Access Compliance Report

Public Rights-of-Way

(Curb Ramps)

Intersection ID: N/A	Main Street: MILLENNIUM_AV	Cross Street: AUDUBON_PARK_DR	Location: S
ADA ID: D3DC308BC288	Ramp Type: BlendTrans1	Initial Pass/Fail: Pass	Overall Compliance: No
		Severity Score: 5.25

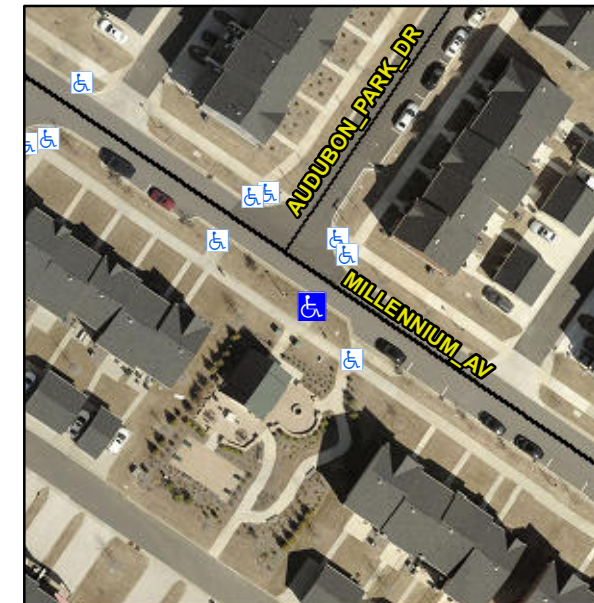
R304.5.3, R305.2, R304.5.4

Compliance	Description	Data	Compliance	Description	Data
N/A	Ramp Length (in)	156.0	Yes	BlendTrans Slope (%)	3.6
Yes	Ramp Width (in)	82.0	No	BlendTrans XSlope (%)	2.7
Yes	Flare Type L	Curbed_NoWalkSurface	Yes	Flare Type R	Curbed_NoWalkSurface
N/A	Flare Slope LT (%)	N/A	N/A	Flare Slope RT (%)	N/A
N/A	Flare Traversable LT?	No	N/A	Flare Traversable RT?	No
Yes	Landing Length (in)	71.0	Yes	DWS Provided?	Yes
Yes	Landing Width (in)	82.0	Yes	DWS Contrast?	Yes
Yes	Landing Slope (%)	0.9	Yes	DWS Length (in)	24.0
No	Landing X Slope (%)	2.4	Yes	DWS Full Width?	Yes
N/A	Landing Curb? (Y/N)	No	No	DWS Offset (in)	5.0
N/A	Shared Landing?	No			
Yes	Gutter Ponding?	No	No	Gutter Slope (%)	8.9
Yes	Gutter Lip Ht (in)	0.0	Yes	Gutter X Slope (%)	1.1
N/A	Painted X Walk1?	No	N/A	Painted X Walk2?	N/A
	X Walk 1 Direction	To NE		X Walk 2 Direction	N/A
	X Walk 1 Width (in)	N/A		X Walk 2 Width (in)	N/A
	X Walk 1 Slope (%)	2.8		X Walk 2 Slope (%)	N/A

X Walk 1 X Slope (%)	1.4		X Walk 2 X Slope (%)	N/A
N/A	Ramp inside XWalk1?	N/A	N/A	Ramp inside XWalk2?	N/A
	Road Slope (%)	1.4		Clear Space?	Yes
	Road X Slope (%)	2.8	N/A	Clear Space to XWalk (in)	N/A
Yes	Any Obstructions?	No	Yes	Storm Grate/Utility Hazard?	No
	Obstruction Type			Storm Grate/Utility Type	
			N/A		N/A
			Yes	Surface Condition? (G/P)	Good
			N/A	Curb Slope (%)	4.6

Remove & Replace Curb Ramp With Two New Directional Ramps or Equivalent. Remove & Replace Gutter.
